SERVICE BULLETIN

SUBJECT: TS-180S LOW 40M ALC

DATE 9/14/79

▼ LPF UNIT (X51-1180-00)

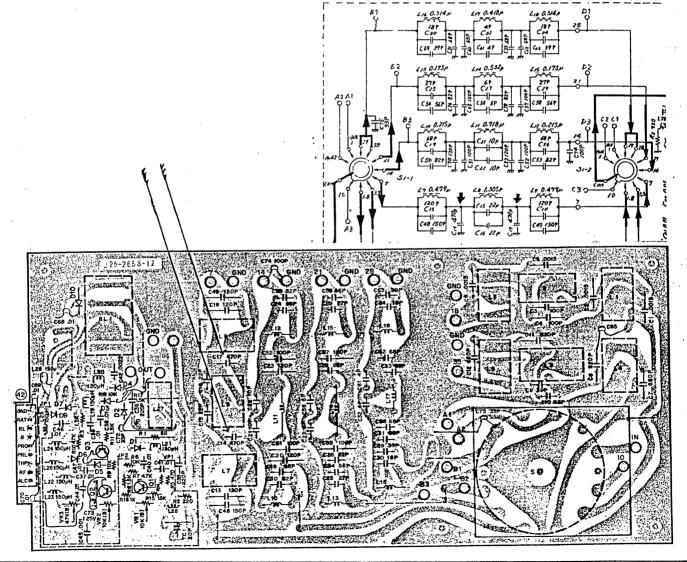
Some operators may experience intermittent reduction or loss of ALC, especially after several minutes transmit time.

On the LPF unit X51-1180-00, change C14, C17 from 470pF to 390pF. Check ALC level and adjust if necessary, per section 4-6 ALC meter adjustment, TS-180S Service Manual.

New Part: CM93D2H390J 390pf + 5% 500V mica or ceramic
